RE: Project Birkdale – Building 1 Lee's Summit, MO Wallace Project No. 2220003

In response to our July 27th site visit and August 17th letter, we have determined the recommended path forward for the southwest corner foundation in coordination with Olsson and your team. These items address the observed conditions as well as information gathered on the as-built condition relative to design basis.

FOUNDATION SECTION

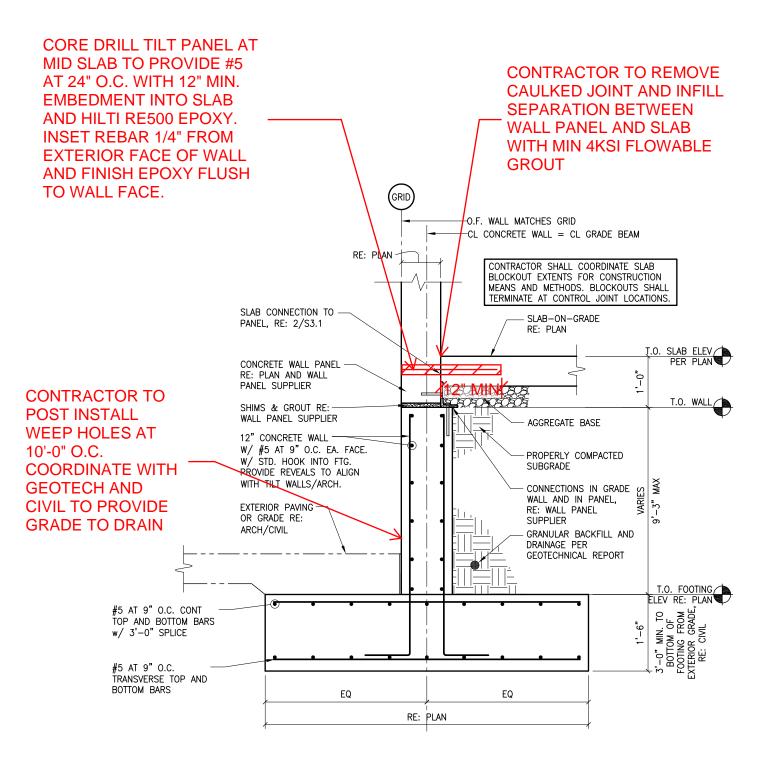
- 1. The tilt panel designer shall review and repair the panels/anchors as required, refer to the July 27 Observation Report.
- 2. Install weep holes at 10'-0" spacing into concrete retaining wall. The location of the weep holes shall be coordinated with Olsson's geotechnical and civil teams as it requires grade to drain. Olsson representation shall be on site to observe the drilling and installation.
- 3. Dowel and epoxy the tilt panel to the slab-on-grade at mid-depth from the exterior. The slab-to-panel joint will require grouting from the interior prior to the setting of the anchors. Refer to the attached redline of the contract detail for additional specification of this item.
